CR-Formv3	
CHANGE REQUEST	
✎ 25.225 CR 24 ✎ rev - ✎ Current version: 3.5.0 ✎

Title:	✎ Inclusion of 1.28Mcps TDD in TS 25.225		
Source:	✎ Siemens/CWTS/CATT		
Work item code:	✎ LCRTDD	Date:	✎ 26.02.2001
Category:	✎ B	Release:	✎ REL-4
	Use <u>one</u> of the following categories: F (essential correction) A (corresponds to a correction in an earlier release) B (Addition of feature), C (Functional modification of feature) D (Editorial modification) Detailed explanations of the above categories can be found in 3GPP TR 21.900.		Use <u>one</u> of the following releases: 2 (GSM Phase 2) R96 (Release 1996) R97 (Release 1997) R98 (Release 1998) R99 (Release 1999) REL-4 (Release 4) REL-5 (Release 5)

Figure A.1: Possible idle periods in a subframe with two occupied timeslots

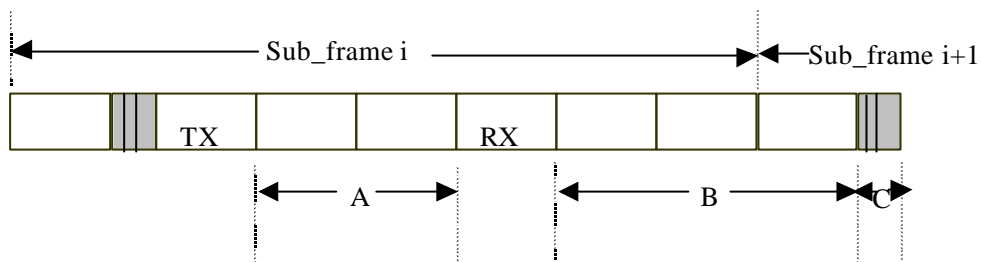
A.2 Low data rate traffic using 1 uplink and 1 downlink slot (for the 1.28 Mcps option)

If a single synthesiser UE uses only one uplink and one downlink slot, e.g. for speech communication, the UE is not in transmit or receive state during 5 slots in each frame. According to the timeslot numbers allocated to the traffic, this period can be split into two continuous idle intervals A and B as shown in the figure below.

A is defined as the number of idle slots between the Tx and Rx slots and B the number of idle slots between the Rx and Tx slots. It is clear that $A+B=5$ time slots and C is equal to the $DwPTS+GP+UpPTS$.

In the scope of low cost terminals, a [0.5] ms period is supposed to be required to perform a frequency jump from 1.28Mcps TDD to GSM and vice versa. This lets possibly two free periods of $A*Timeslots-1$ ms and $B*Timeslots+C-1$ ms during which the mobile station can monitor GSM, Timeslots being the slot period.
